Re: Scholls Valley Heights; Phases 4 – 7 Design Review; CWS file 17-001934 (Tax map 2S10600 Tax lot 00301, 00302)

SCHOLLS VALLEY HEIGHTS - PHASES 4, 5, 6 & 7
 CITY OF BEAVERTON, OREGON

Project: Scholls Valley Heights Phase 4-7 Design Review
PDG No. 386-002

Service Provider Letter

Project: SCHOLLS VALLEY HEIGHTS
 No.: 332-001
 Type: ENGINEERING
 Sheet: **C0.2**

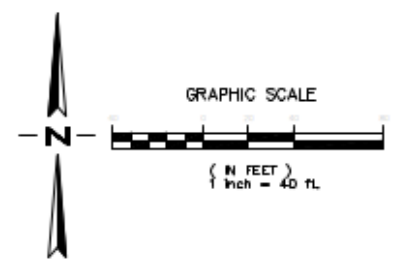
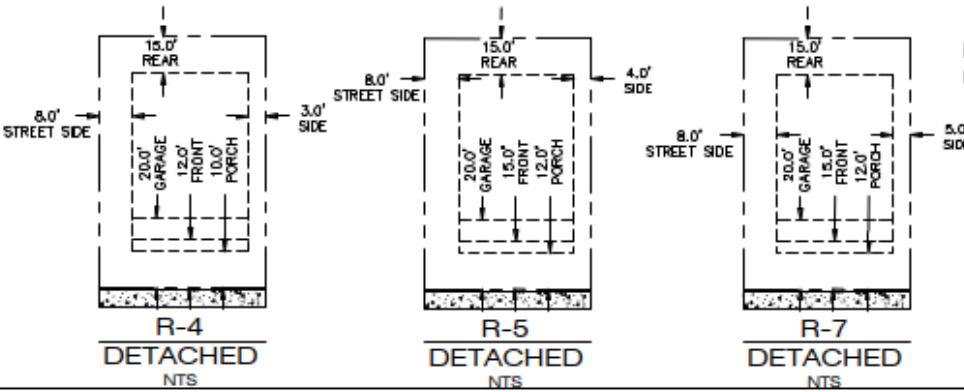
Clean Water Services has reviewed the Service Provider Letter issued on September 18, 2017 and the Amended SPLs issued on October 9, 2018 and April 2, 2019 for file 17-001934. District staff has evaluated the Service Provider Letter conditions and project plans for consolidated Phases 4 – 7 and found them to be in compliance with Resolution and Order 19-5 (R&O 19-5), as amended by Resolution and Order 19-22 (R&O 19-22). Please attach this letter to the existing Service Provider Letter for all applications made after November 2019, to demonstrate compliance with R&O 19-5, as amended by R&O 19-22.

- PHASES 1 AND 2 OF SCHOLLS VALLEY HEIGHTS SUBDIVISION TO BE PERMITTED PRIOR TO OR CONCURRENT WITH THIS PERMIT.
- WALLS WITHIN STORMWATER FACILITY TRACT 'K' SHALL BE OWNED AND MAINTAINED BY THE CITY OF BEAVERTON
- WALLS WITHIN OPEN SPACE TRACT 'L' SHALL BE OWNED AND MAINTAINED BY THE HOA
- TRACT 'G' IS SUBJECT TO A CITY OF BEAVERTON STORM AND SANITARY SEWER EASEMENT OVER ITS ENTIRETY.
- TRACTS 'G' AND 'H' ARE PRIVATE STREET TRACTS AND SUBJECT TO ACCESS EASEMENTS OVER THEIR ENTIRETY FOR THE BENEFIT OF THE LOTS WITHIN SCHOLLS VALLEY HEIGHTS SUBDIVISION
- TRACT 'H' IS SUBJECT TO A CITY OF BEAVERTON SANITARY SEWER EASEMENT OVER ITS ENTIRETY.
- TRACT 'K' IS SUBJECT TO A CITY OF BEAVERTON SEWER, SURFACE WATER, DRAINAGE AND DETENTION EASEMENT OVER ITS ENTIRETY.
- TRACT 'L' IS A PRIVATE OPEN SPACE TRACT AND SHALL BE OWNED AND MAINTAINED BY THE HOA.

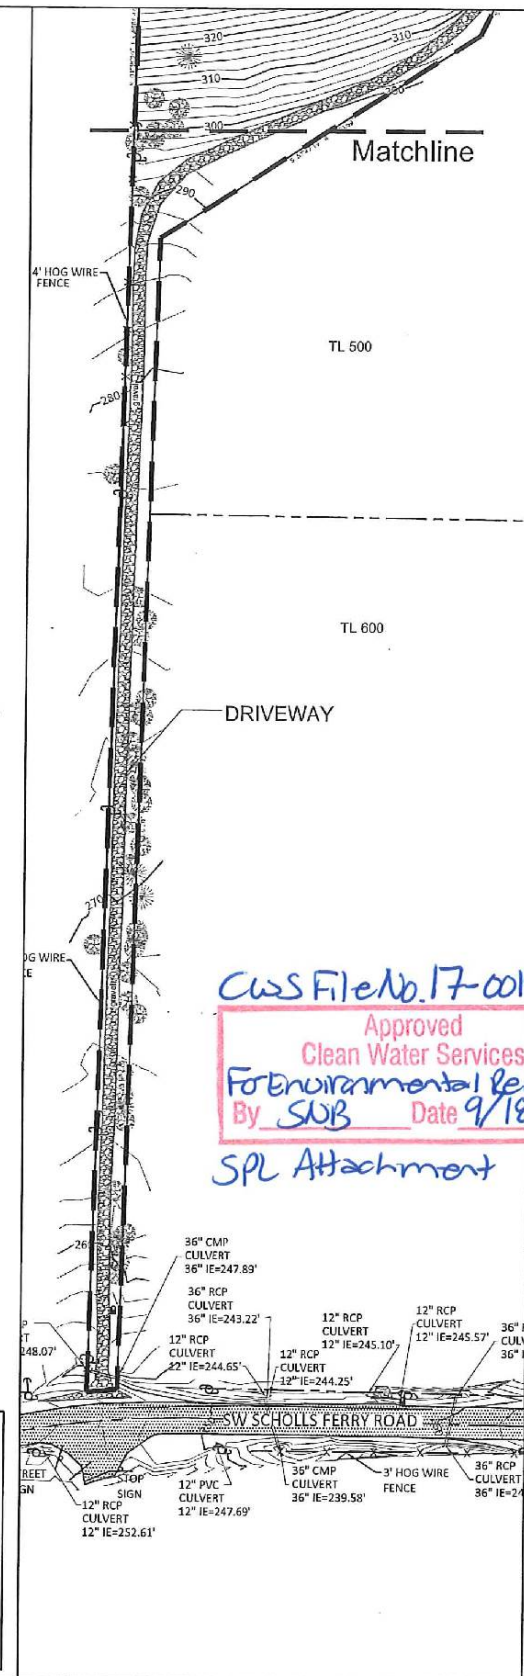
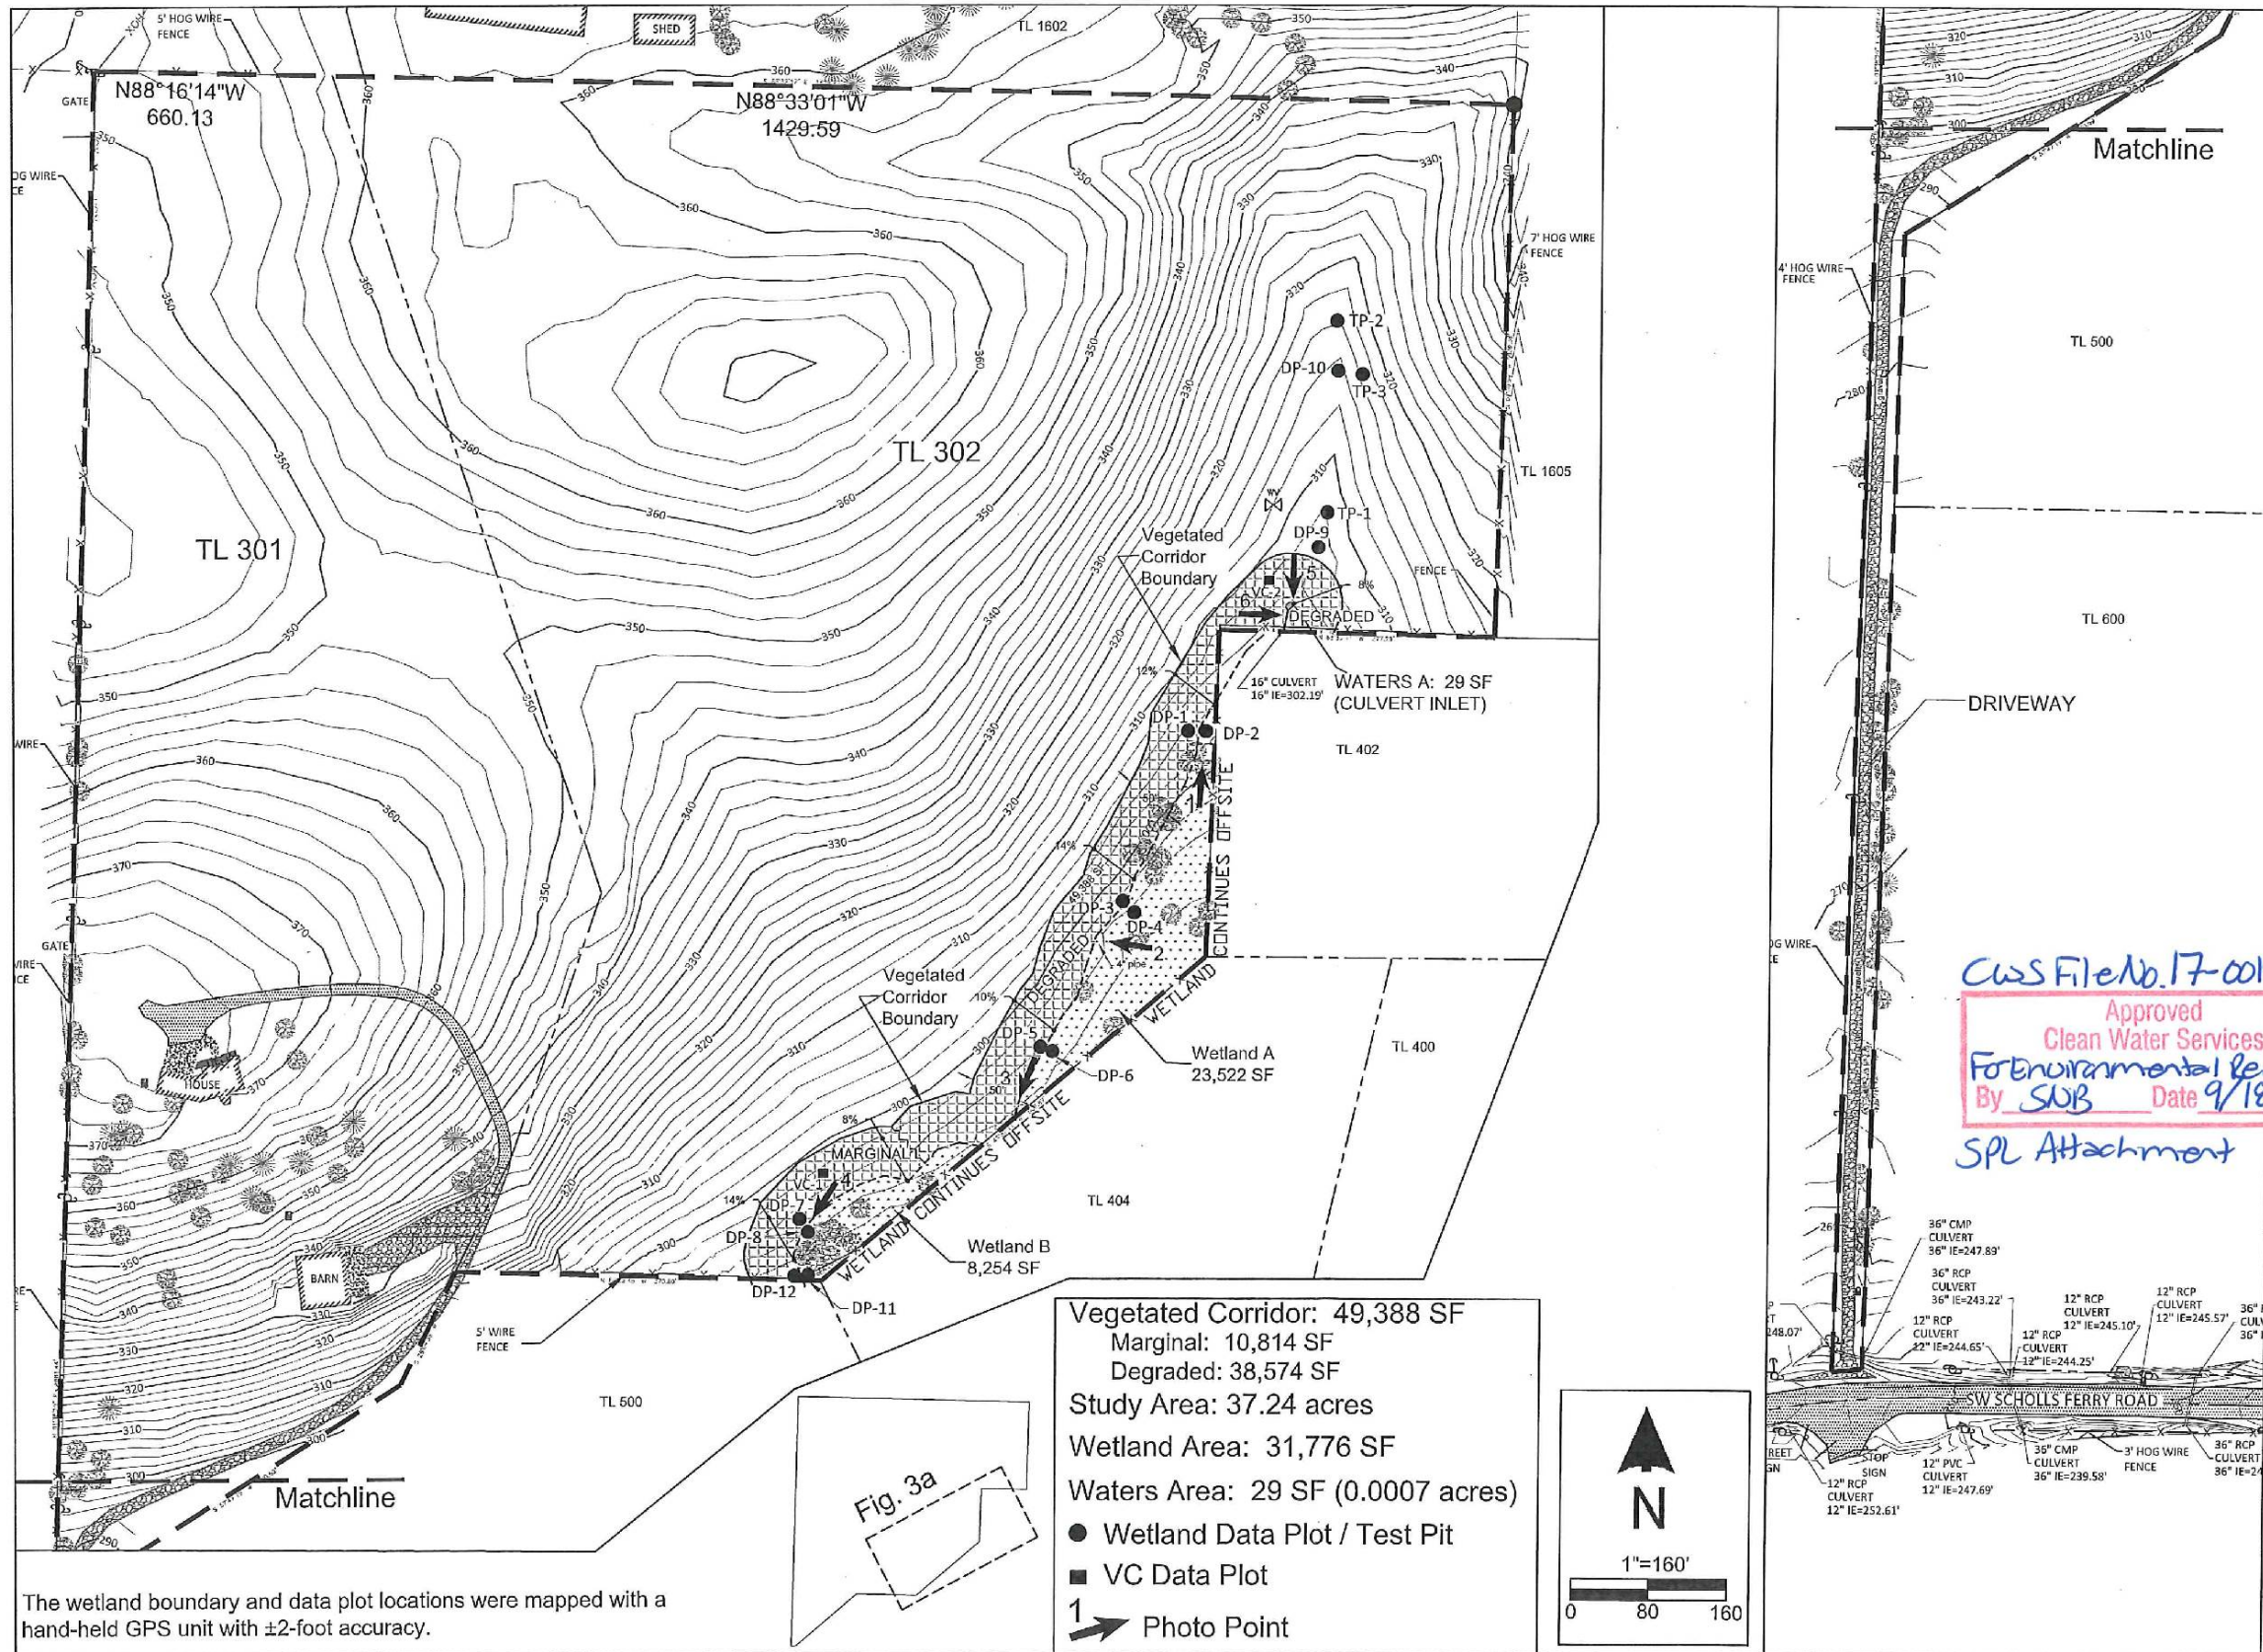
In order to comply with Clean Water Services water quality protection requirements the project must comply with the following conditions:
